# D Block - Ground floor

Client  
 DEBACATING SOCIETY TRUST OF SRI LANKA  
 UNIVERSITY GRANTS COMMISSION

Drawing Title  
 AS BUILT DRAWING OF  
 IT ARRANGEMENT  
 BASEMENT FLOOR

Drawing Title:  
**AS BUILT DRAWING OF  
IT ARRANGEMENT  
UPPER FLOOR**

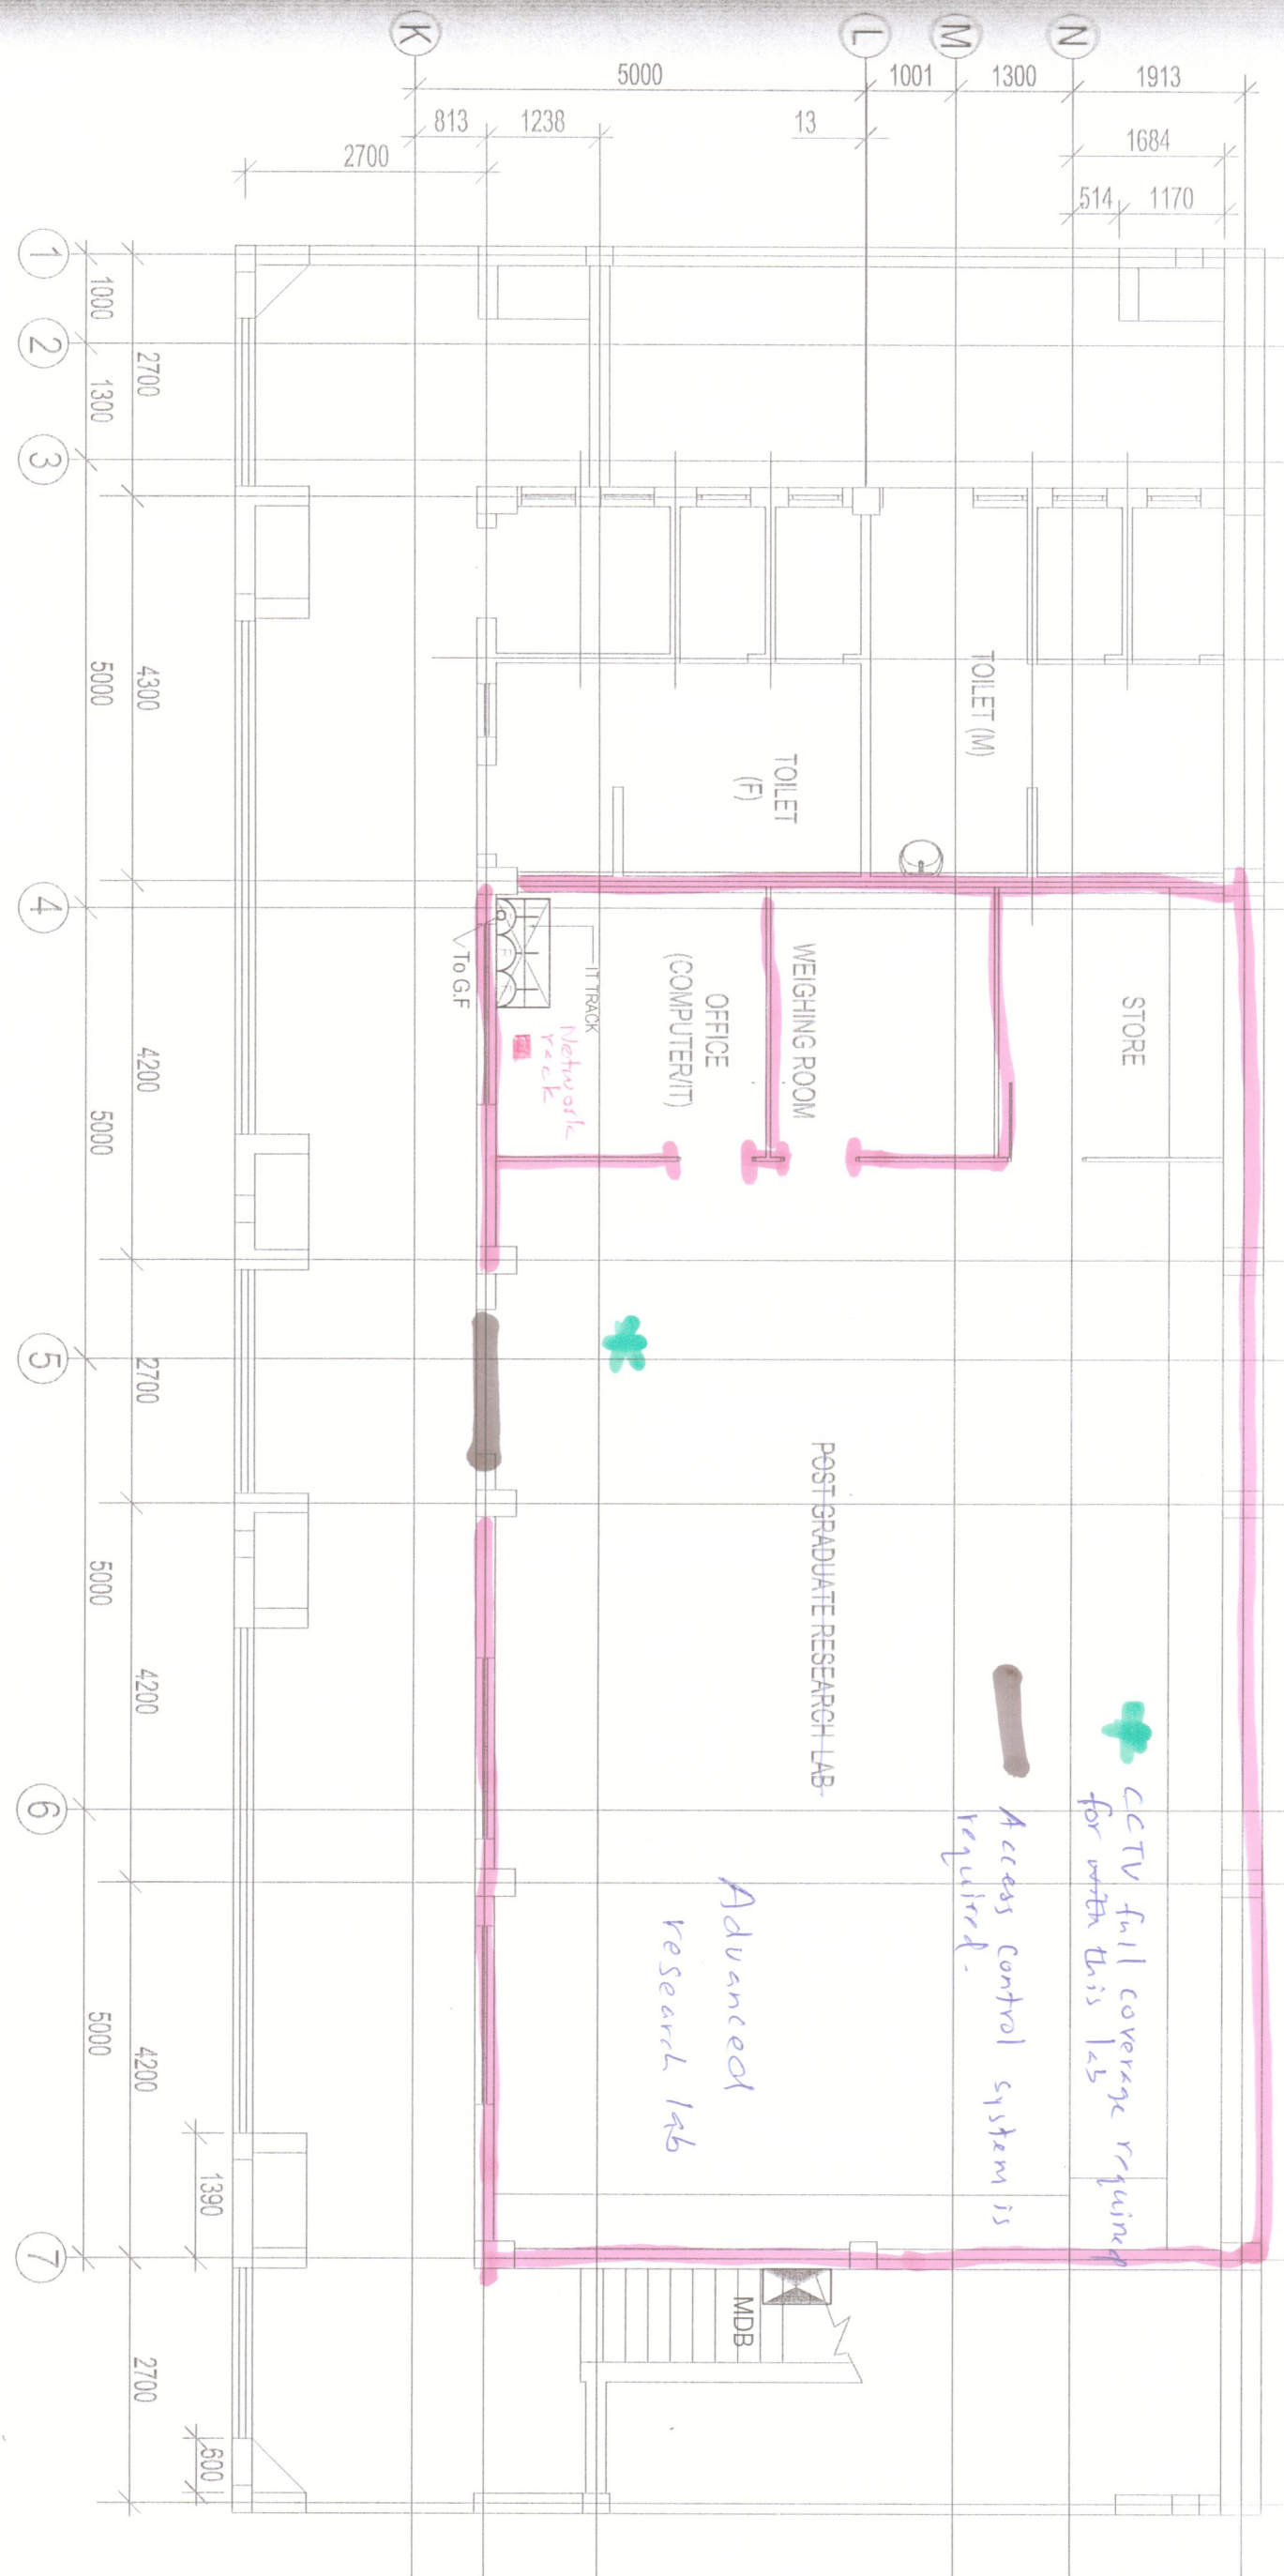
CCTV full coverage required for water lab  
 Access control system is required.

**Block-G ground floor**

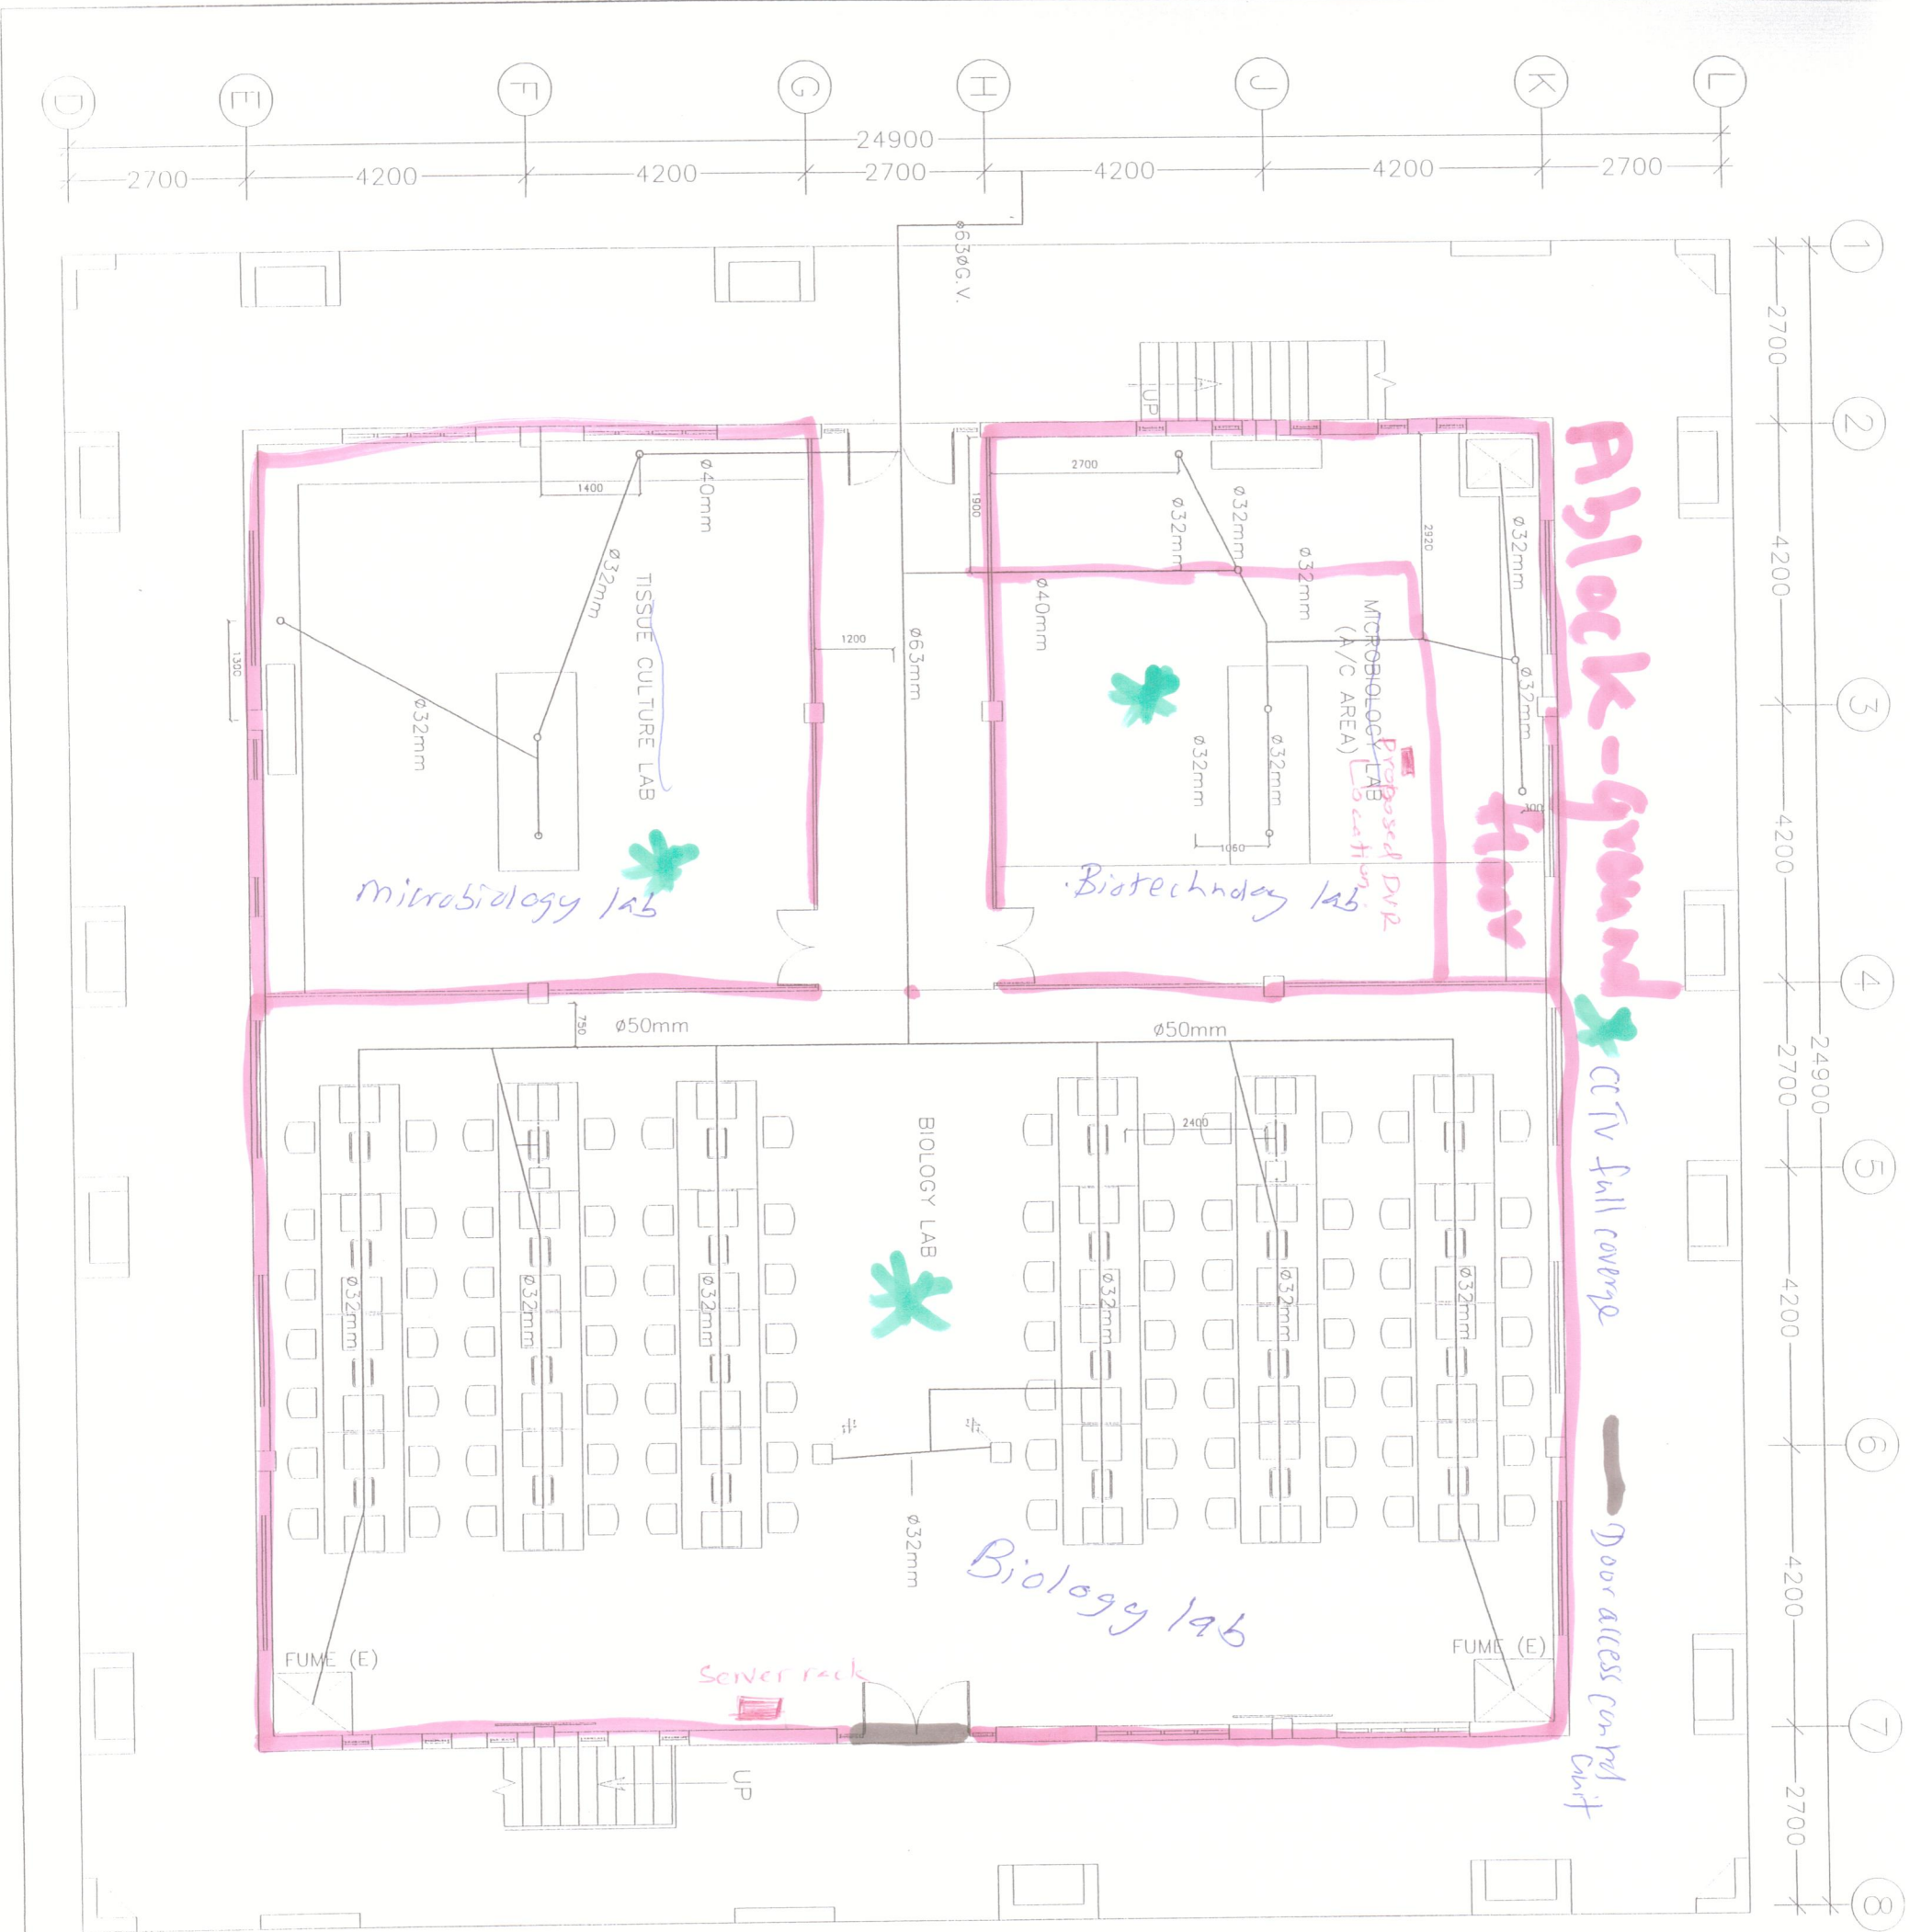
CCTV full coverage

Door access control unit

Proposed DVR (A/C AREA)

*Block - 1st floor*

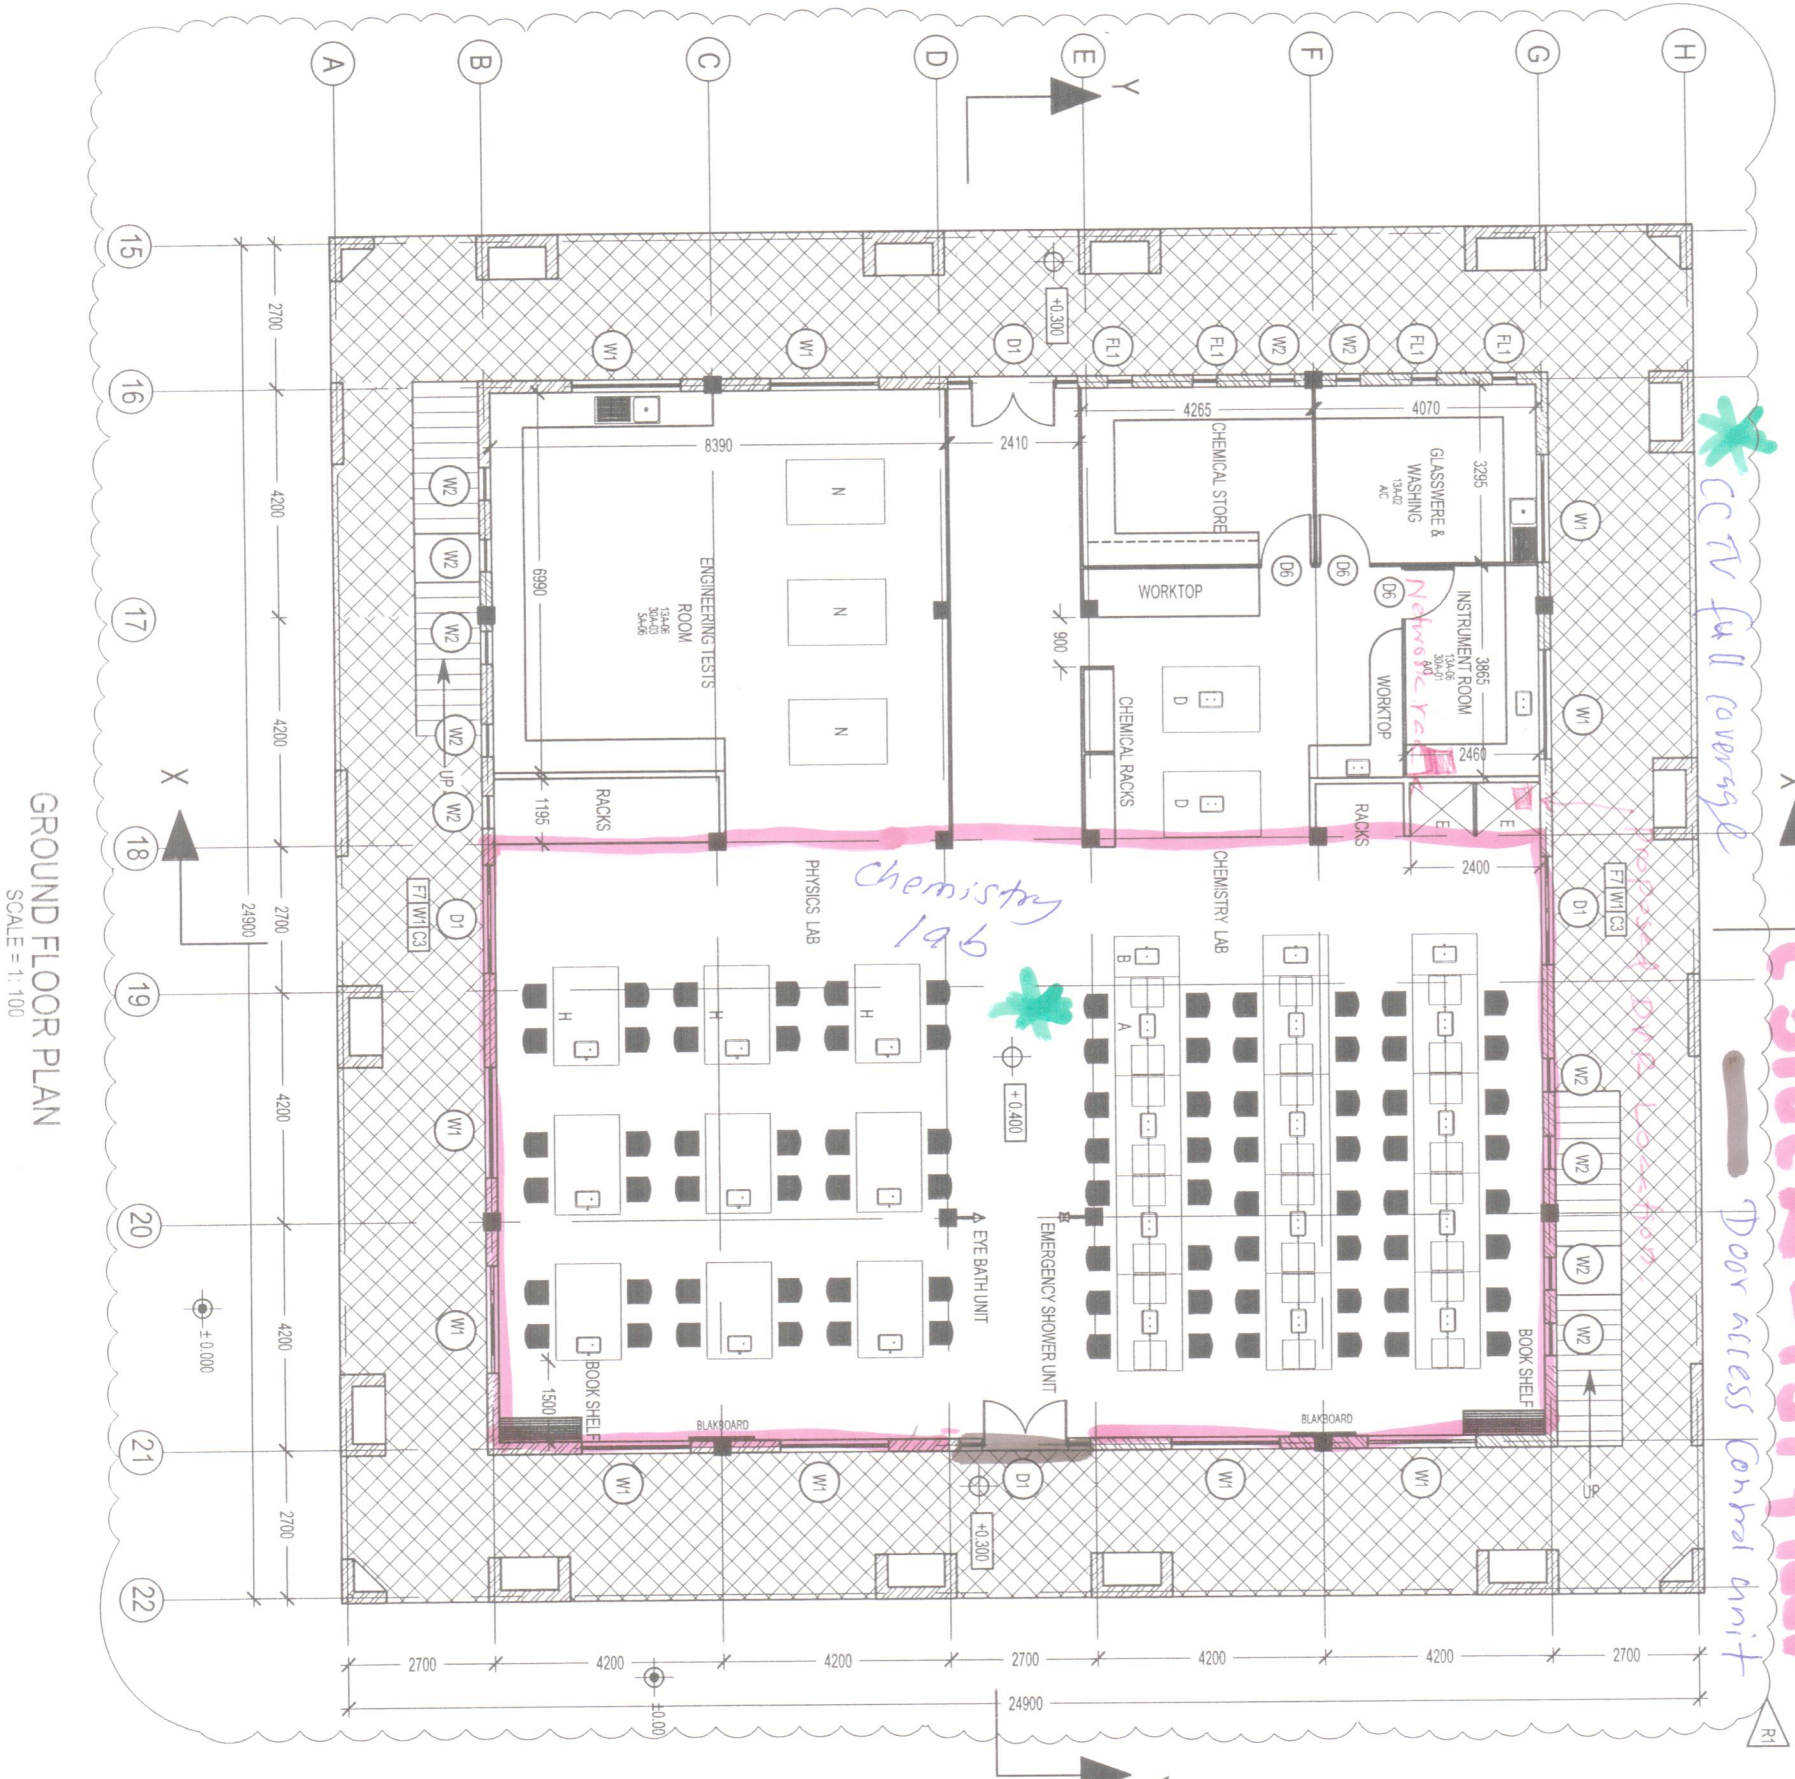
*CCTV full coverage*

*Door access control unit*
